CITY OF ALBUQUERQUE

Re: Take 5 Oil Change
1125 Snow Vista Blvd. SW
Traffic Circulation Layout
Engineer's Stamp 09-19-23 (M09-D021C)

Based upon the information provided in your submittal received 10-19-23, the above referenced plan cannot be approved for Building Permit until the following comments are addressed:

C2.0

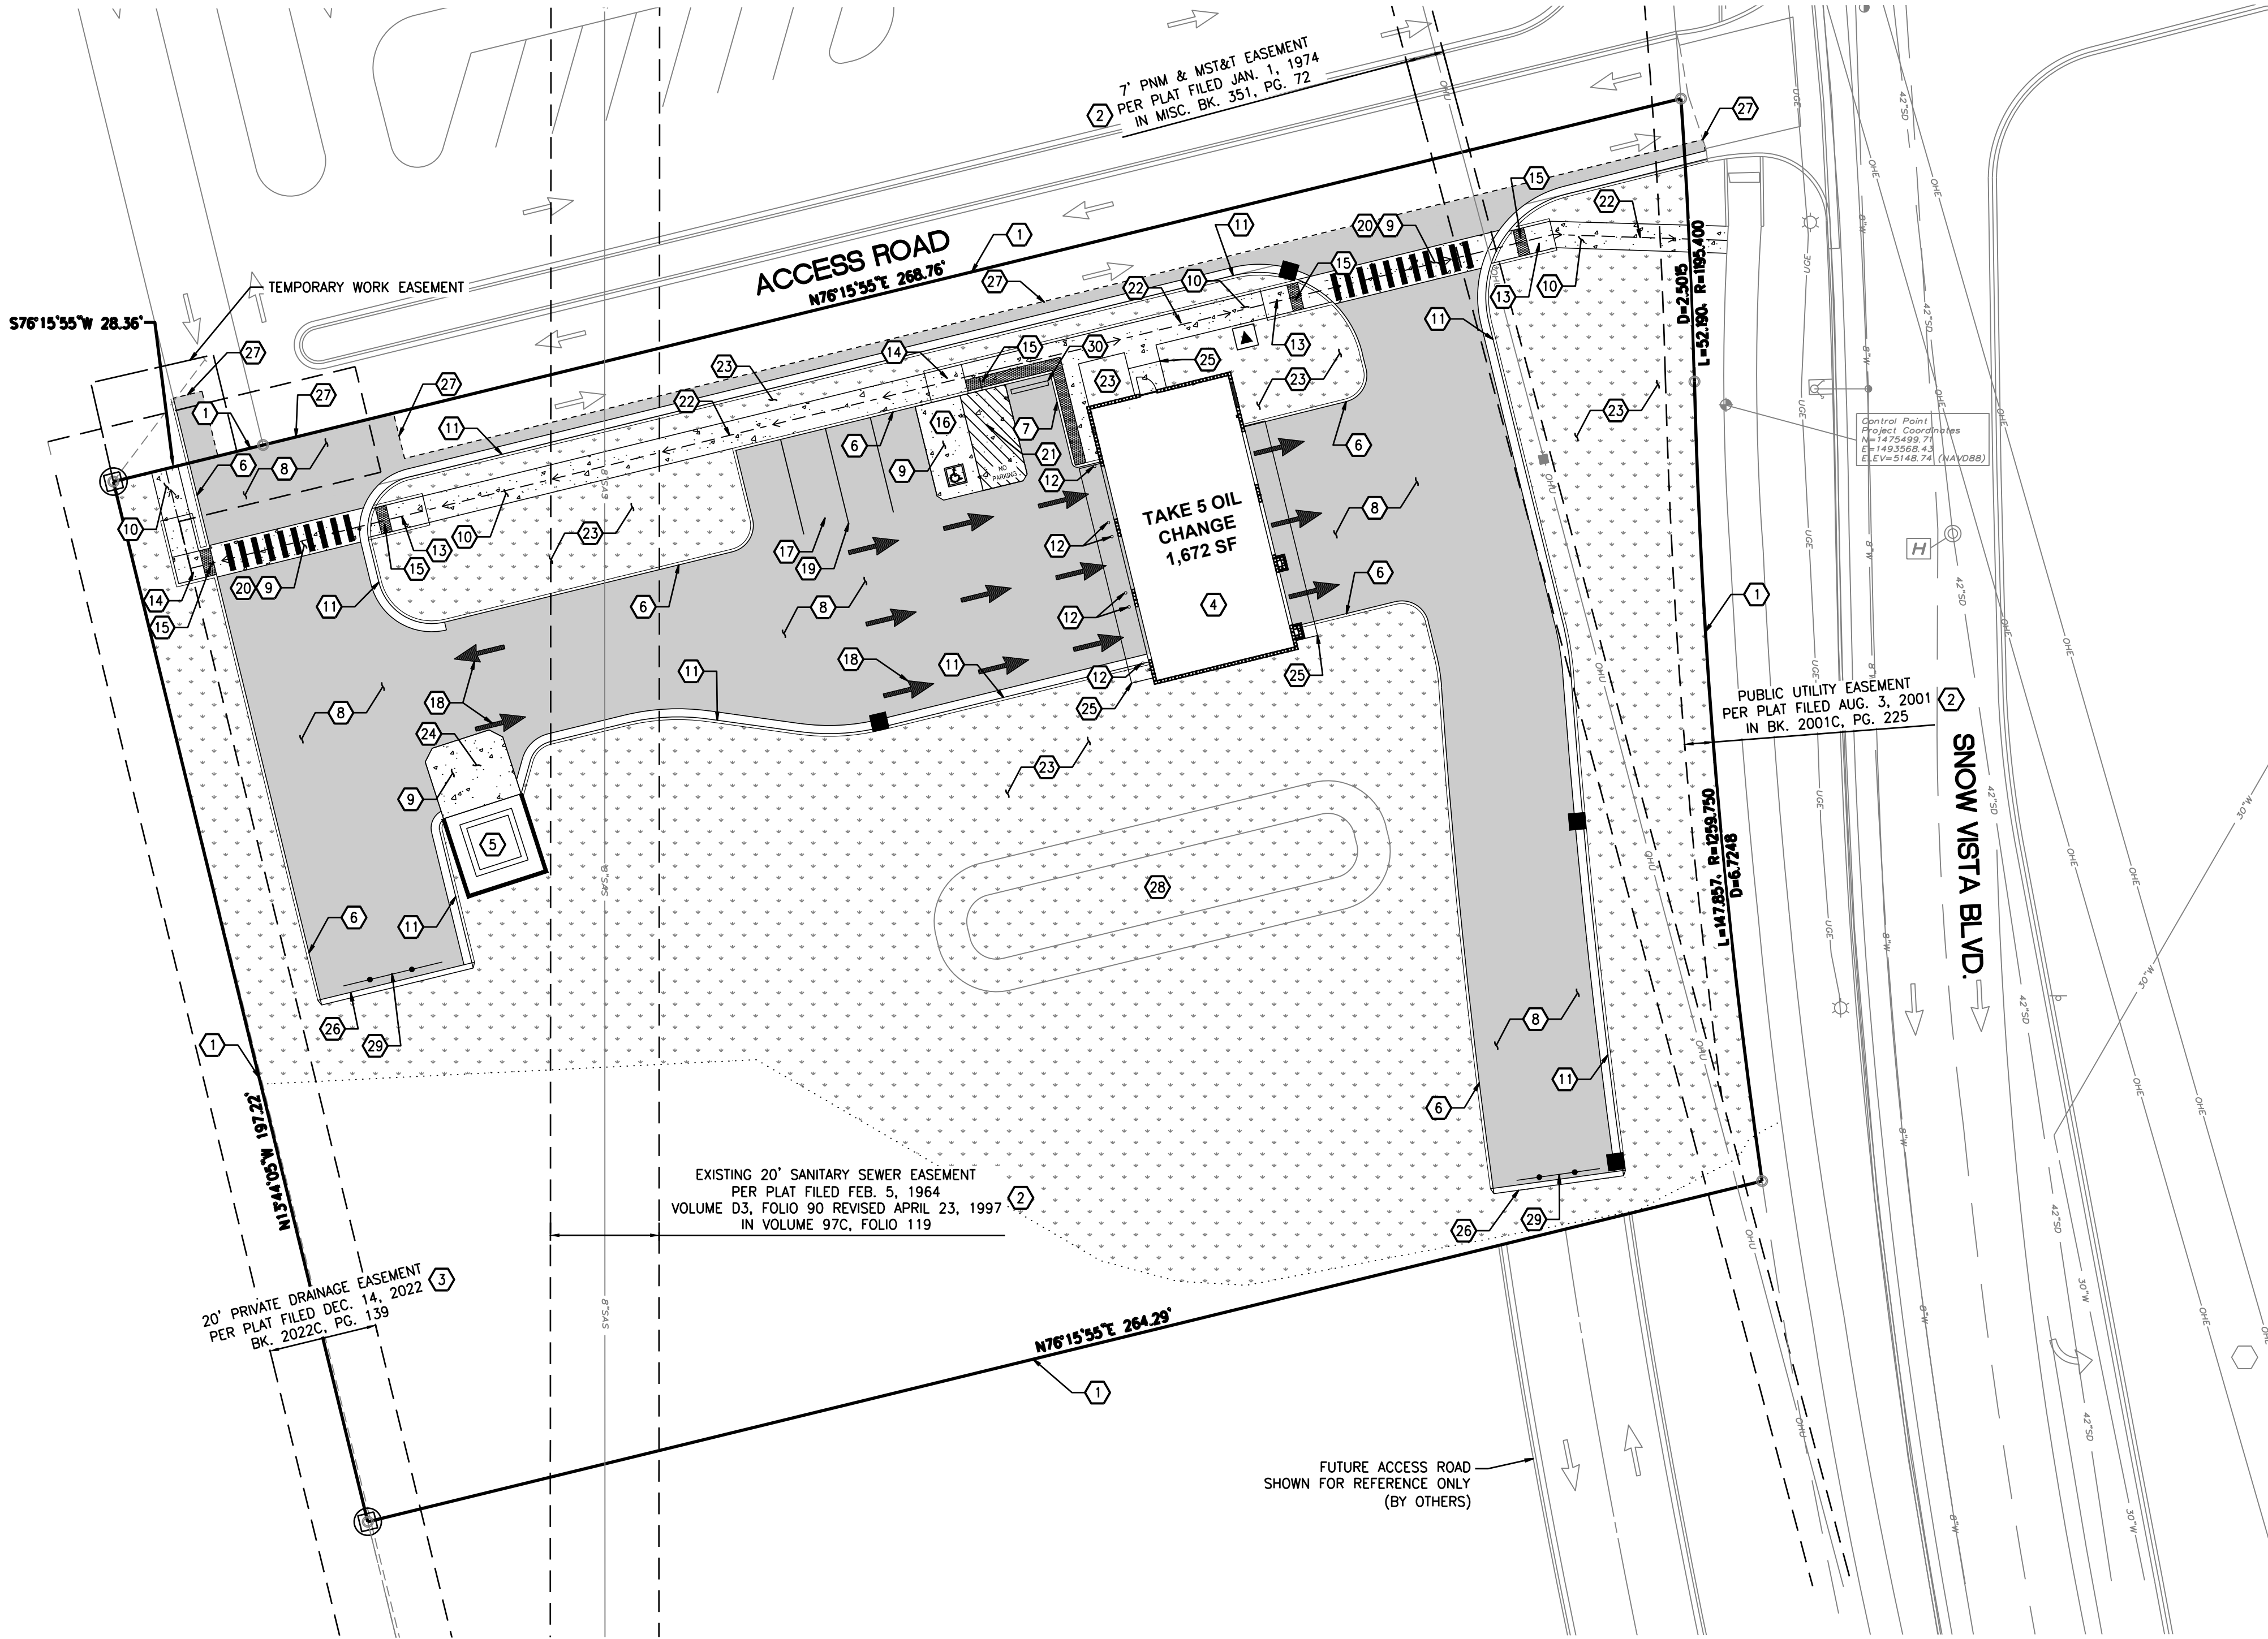
1. Please show a vicinity map and the parking calculations table on the site plan sheet C2.0.
2. Provide approved plat showing the shared accesses agreement.
3. List the number of Motorcycle and Bicycle parking spaces required by the IDO.
4. Please show on the site plan the existing site access and sidewalk width.
5. Show all drive aisle widths and radii. Some dimensions are not shown.
6. The minimum drive aisle dimensions are shown below

7. The ADA parking space and pathway appear to be drawn differently on the details sheet. Please address this concern.

11. The pavement marking "MC" should be shown in the opposite direction for motorcycles entering the parking space.
12. All bicycle racks shall be designed according to the following guidelines:

16. List radii for all curves shown; for passenger vehicles. Radius for delivery trucks, fire trucks, etc. is 25 ft. or larger.
17. Per the IDO, a 6 ft. wide ADA accessible pedestrian pathway is required from the public sidewalk to the building entrances. Please clearly show this pathway and provide details.

19. Refuse vehicle maneuvering shall be contained on-site. The refuse vehicle shall not back into the public right of way.; provide a copy of refuse approval.

22. Show the Intersection clear sight triangle and add the following note to the plan: "Landscaping and signage will not interfere with clear sight requirements. Therefore, signs, walls, trees, and shrubbery between 3 and 8 feet tall (as measured from the gutter pan) will not be acceptable in the clear sight triangle.
